SERVICE BULLETIN

BULLETIN NO: 11-008

TITLE: Rotary Encoder Upgrade

PRODUCT SERIES / MODEL: Various Harsco Rail Equipment

FIGURE 1
TYPICAL ROTARY ENCODER APPLICATION

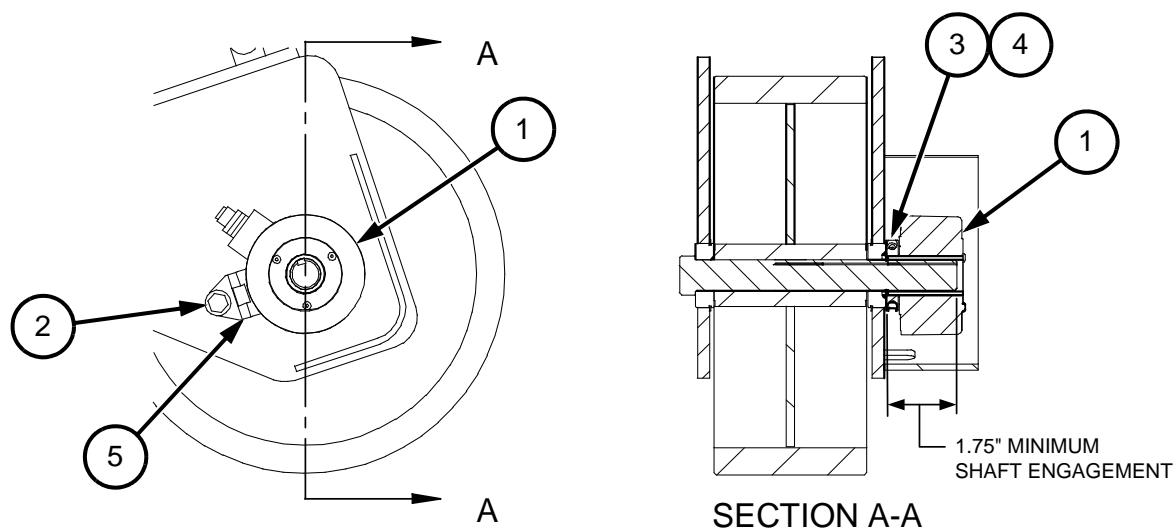
Replacing Rotary Encoder - See Figure 1

Note: Some applications have two encoders installed on the shaft. The second encoder is supplied as a back-up incase one encoder fails. Due to the fact that the new encoders are wider, it is unlikely that two encoders can be installed on the shaft. The outside encoded may not have the necessary 1.75 inch engagement on the shaft.

5. Disconnect the electrical cable from the encoder (1). Inspect the cable and connector for damage. If damage is found, replace the electrical cable.
6. Remove the dust cover from the encoder. Remove the tether securing cap screw and washer (2).

7. Use a 7/64" hex allen wrench to loosen the #6-32 hex socket screw (3) that secures the split collar (4). Slide the old encoder off of the shaft using care not to lose the encoder key.

8. Mount the supplied tether (5) to the new encoder (1), using the old encoder for positioning reference.
9. Slide the new encoder onto shaft aligning the encoder key with one of the slots in the encoder hollow shaft. Apply Loctite 242 Thread Locker to the #6-32 hex socket screw (3). Install the screw in the split collar and torque to 8 - 10 lb-in.

10. Make sure plastic washer is located in the hole on the tether. Apply Loctite 242 Thread Locker to the tether securing cap screw. Install the tether securing cap screw and washer (2). Torque the cap screw to 125 - 150 lb-in.

11. Install the dust cover on the encoder and secure with the provided fasteners. Reconnect the electrical cable.
12. Safely return the machine to operating condition. Operate the machine to verify correct installation and function.
